# UCS M5前端DIMM人口卷标不匹配文档

本文描述不反射当前线文档的老UCS M5前端DIMM人口卷标的一个问题。

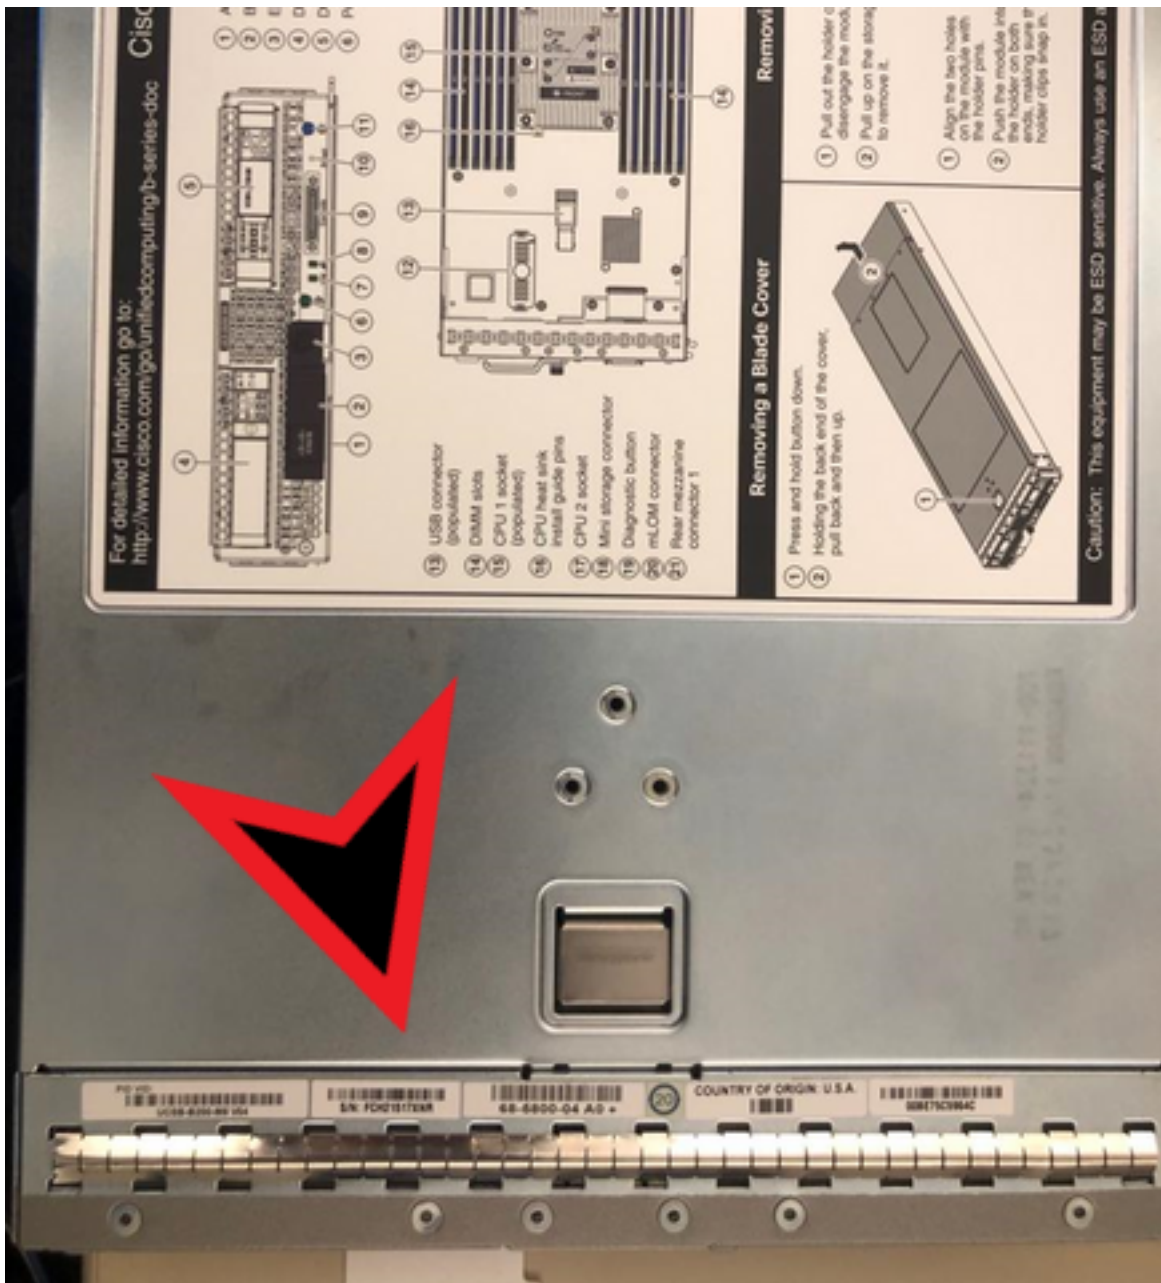
被发现DIMM人口的最佳的配置跟specs不同最初发布的POST FCS测试。原始人口规则适当地运作，但是最佳性能在文档可以得到使用最新的指南如发布。在前端盒盖下的卷标更改了在2018年5月实现的ECO EA553015下，并且技术文档在2017年12月更新。15K-20K前端近似装备原始DIMM人口卷标。

- UCS B200 M5
- UCS B480 M5
- 上层复盖(800-46239-01)有rev B0 (固定的卷标有rev C0)

- 顶层装配编号(68-5800-04)有rev A0 (修正版本是B0)

原始DIMM人口卷标不是不正确的，但是用户应该被导向到最新和最最佳的配置的线文档。

# Cisco UCS B480 M5 Memory Slot Locations

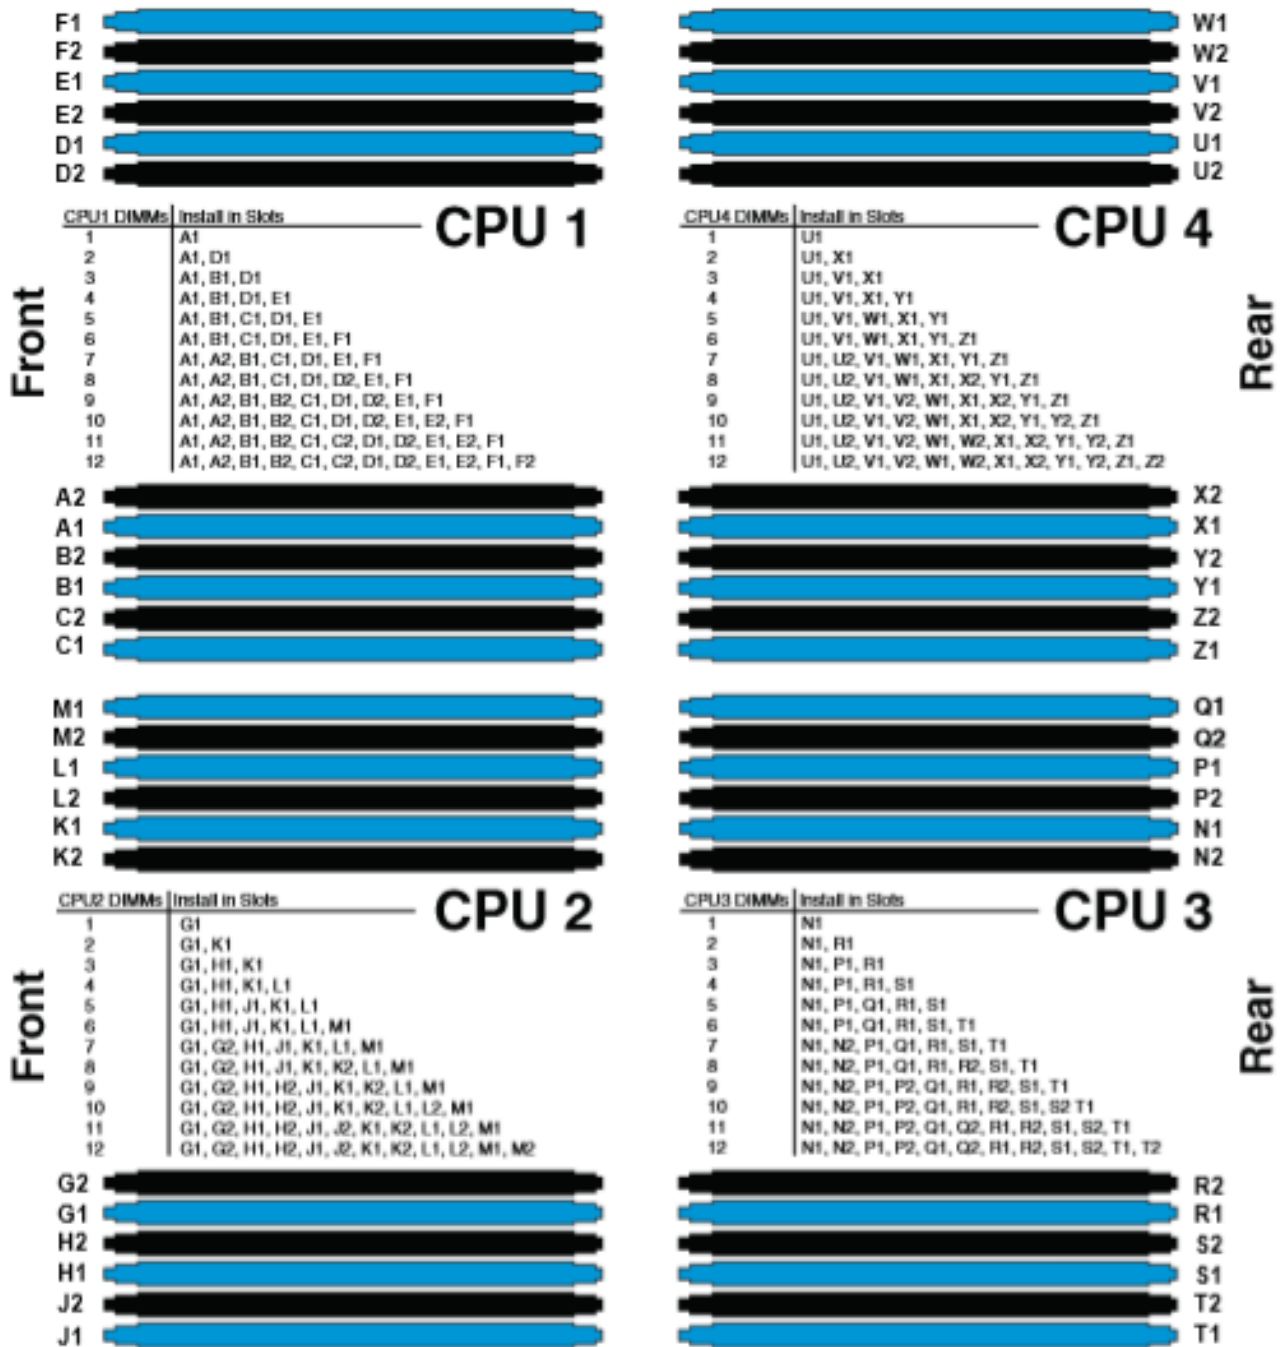
供参考，这是从B480-M5的老卷标：
